Docket Item # 10  
BAR CASE # 2008-0081

BAR Meeting  
May 28, 2008

**ISSUE:** Alterations to previously approved plans

**LOCATION:** 227 North West Street

**Figure 2. Elevations.**

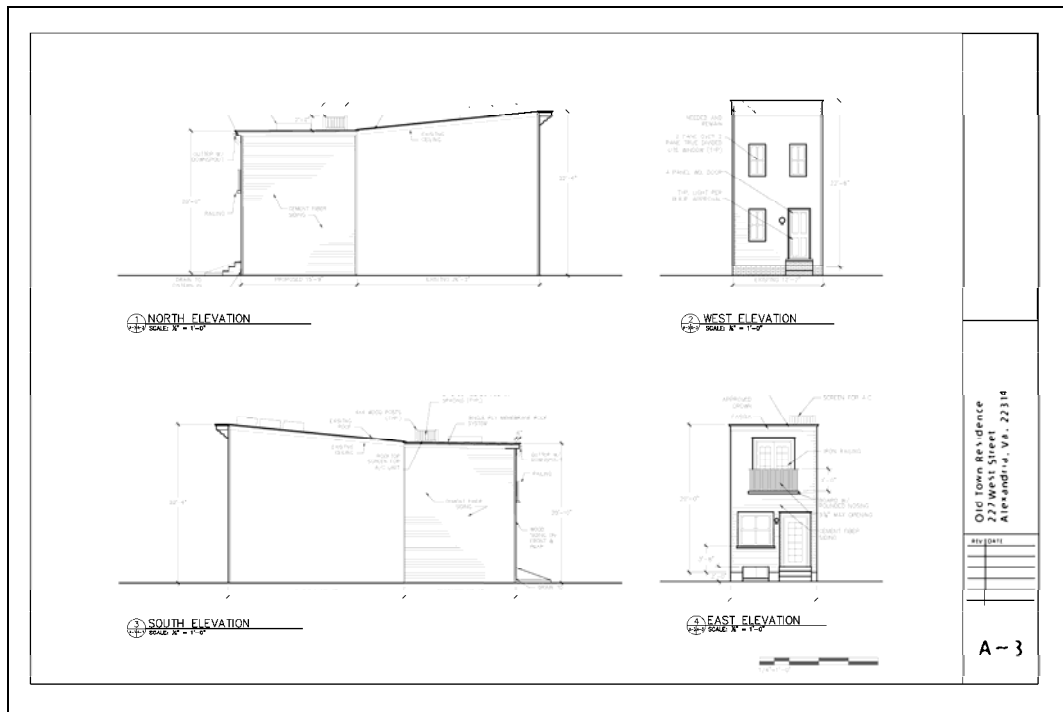
In the opinion of Staff, the increase in width of the addition and the change in the rear fenestration pattern are acceptable. The addition is of a reasonable size and it does not overwhelm the existing house or adjacent properties. The design of the addition and materials used are compatible with the simple vernacular design of the 1890s house and comply with the *Design Guidelines* for residential additions. In addition, Staff believes the proposed alterations to the existing historic house are appropriate. The replacement windows and door and the relocation of the electric meter will return the house closer to its historic appearance.

The drawings note that the front of the house will have wood siding. Staff assumes that the existing wood siding which appears generally in good condition will remain. The exposed south side of the house is clad in brick tec siding but the drawings do not indicate the treatment of this facade. It is assumed that the brick tec covers wood siding. It is not clear from the plans what the intent is, but the applicant has confirmed to Staff that the south side of the existing house will be clad in wood siding. If original siding exists and is in good condition, staff would recommend that this be repaired and retained. If the condition of the siding is poor, staff recommends that the applicant install the same type of wood siding that is on the front of the house. The applicant should work closely with staff to determine the most appropriate course of action once the brick tec siding is removed.

1. That there be no parking space on the property;
2. That the applicant work with Staff to determine if any historic wood siding exists beneath the brick tec on the south elevation;

3. That if historic siding exists and is in good condition, this should be repaired and retained. If the condition of the siding is poor, the applicant should install the same type of wood siding that was originally on the house;
4. That the fiber cement be used only on the addition;
5. That the nails not show in the installation of the siding;
6. That smooth fiber cement siding be used;
7. That a mock up of the photo-voltaic panels be approved by staff;
8. That the following statement appear in the General Notes of all site plans so that on-site contractors are aware of the requirement:

Figure 7. Visibility diagram.

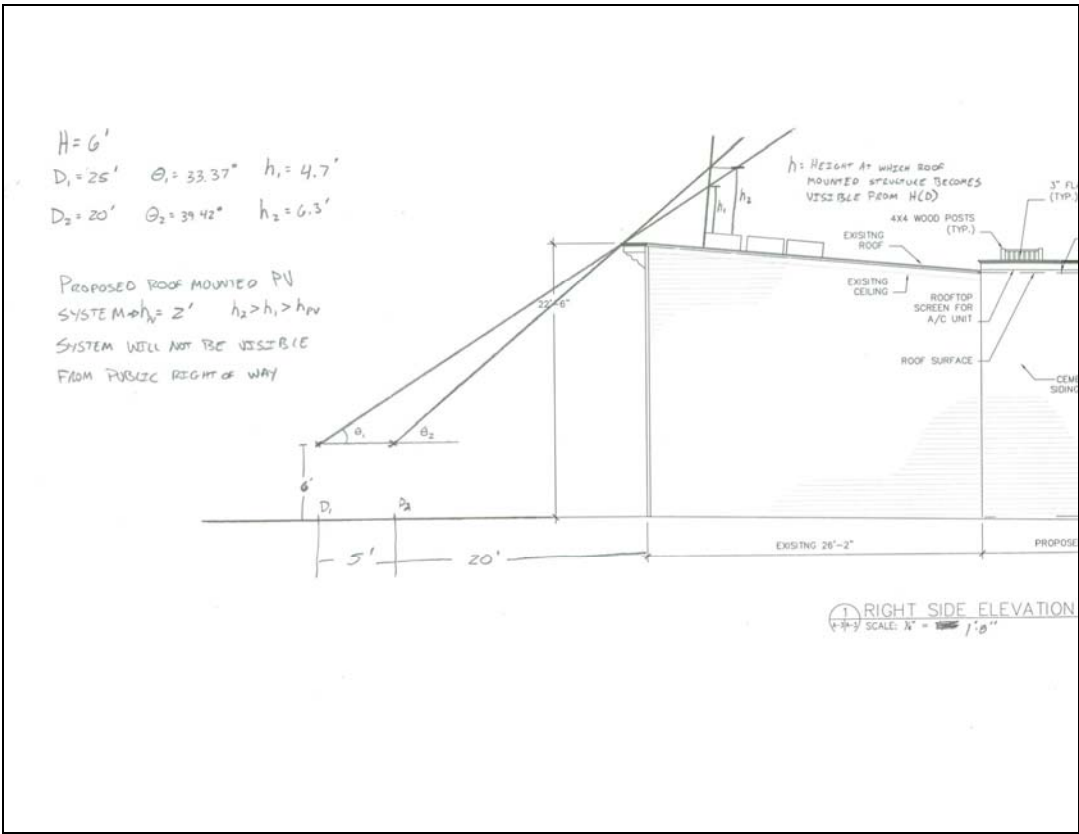
Staff does have concerns about the visibility of the photo-voltaic panels on the roof of the historic house. The applicant believes that the panels will not be visible. The applicant has stated that a mock up of the panels will be done for staff review prior to their installation.
